MONTGOMERY COUNTY HISTORIC PRESERVATION COMMISSION
STAFF REPORT

Address:	13 Columbia Avenue, Takoma Park	Meeting Date:	1/21/2026
Resource:	Non-Contributing Resource Takoma Park Historic District	Report Date:	1/14/2026
Applicant:	Neal Cohen & Briana Maley	Public Notice:	1/7/2026
Review:	HAWP	Tax Credit:	No
Permit No.:	1144792	Staff:	Laura DiPasquale
Proposal:	Hardscape alterations, fenestration alterations, and new fence

Figure 3: Existing site plan showing the proposed pavement removal and driveway/parking pad enlargement, proposed fence, window, and tree removal locations.

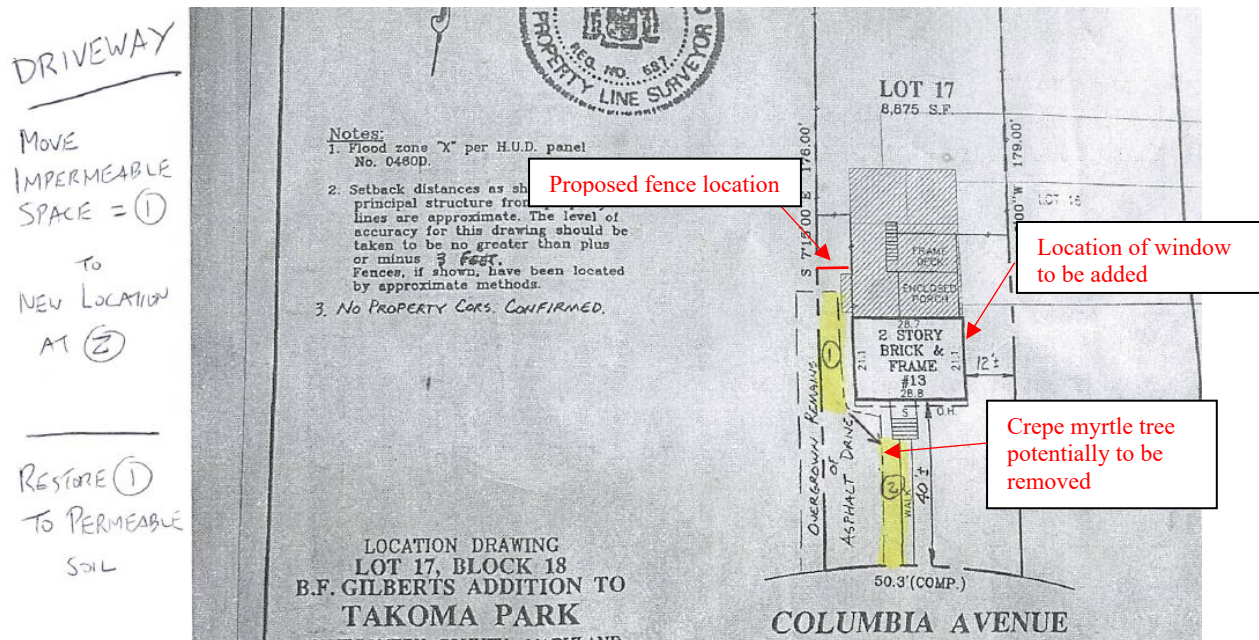
1. The width of asphalt paving must not exceed that of the existing 13-ft wide driveway. The asphalt may be replaced with gravel, tinted concrete pavers, cobblestone, TurfStone, or other similar permeable masonry materials, if desired, and the shoulder may be any of these materials. The applicants must submit final materials selections and updated annotated site plan to staff.

Figure 9: Site plan showing the existing fence to be replaced and proposed fence location.

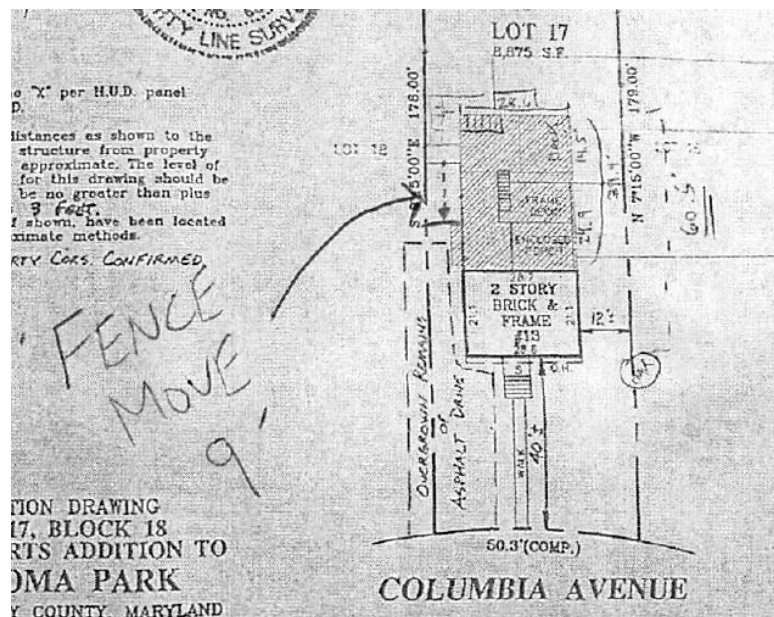
On the west side of the house, the applicants propose to move the existing fence line approximately 9 feet towards the street to align with that of the neighboring property. Staff finds that the fence will remain behind the rear wall plane of the main block and have limited visibility from the public right-of-way. Staff finds that the proposed horizontal wood fence is appropriate for use on this Non-Contributing resource based on a lenient level of review per the *Guidelines* and Chapter 24A-8(d).

Revised Site Plan: Driveway for 13 Columbia Ave. Takoma Park, MD 20912 – DRAFT

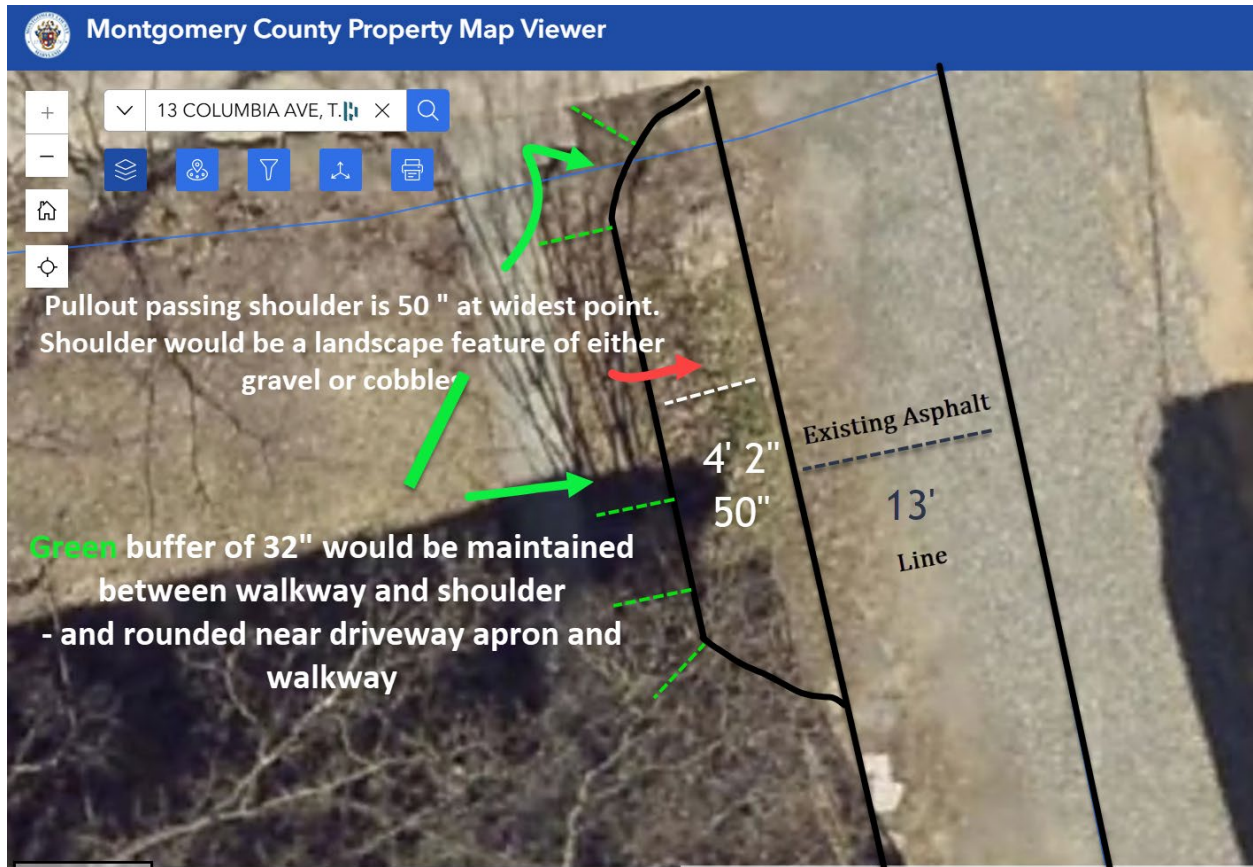
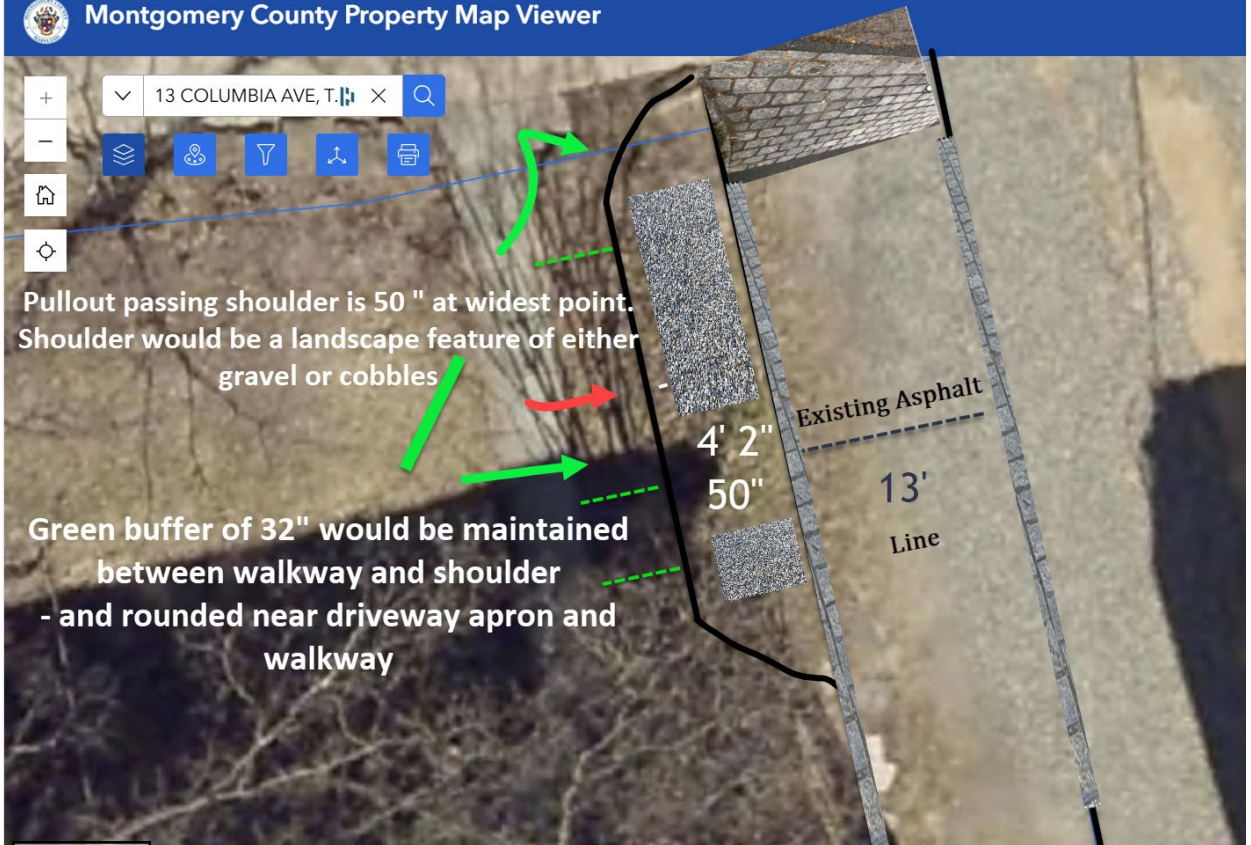
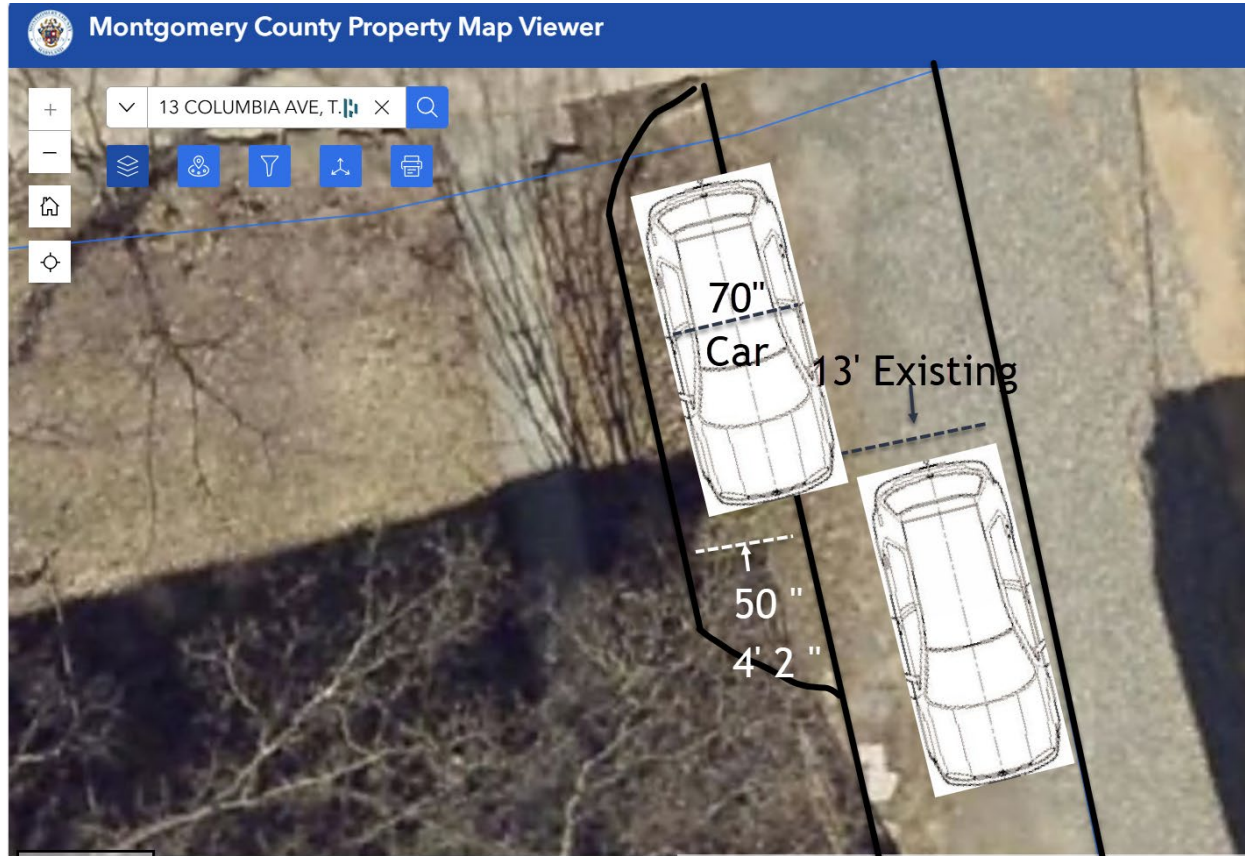
Staff notes that while the *Guidelines* identify driveways and parking pads as being located to the rears and sides of properties in the Takoma Park Historic District. Staff finds that, while the proposed shoulder would extend partially in front of the existing house, the main driveway itself would remain located on the side of the house, in keeping with the *Guidelines*. Further, given the location of the Non-Contributing property between two other Non-Contributing resources with similar existing driveways/hardscapes, staff finds that the proposal will not impair the character of the district or surrounding resources, in keeping with Chapter 24A-8(d). Staff finds that the proposed cobblestone apron and asphalt paving to replace existing asphalt paving is appropriate for the main portion of the driveway as an in-kind replacement, as would be gravel, stone or concrete pavers, permeable tinted concrete, or TurfStone pavers, per Chapter 24A-8(b)(2) and *Standard 9*. Staff finds that the differentiation of the shoulder from the proposed asphalt in a textured, permeable material such as those mentioned above, and the proposed cobblestone borders are also compatible with the eclectic nature of Takoma Park per the *Standards* and *Guidelines*. Staff recommends that the HPC allow the applicants to work with staff on the final material selection.

1. The width of asphalt paving must not exceed that of the existing 13-ft wide driveway. The asphalt may be replaced with gravel, tinted concrete pavers, cobblestone, TurfStone, or other similar permeable masonry materials, if desired, and the shoulder may be any of these materials. The applicants must submit final materials selections and updated annotated site plan to staff.
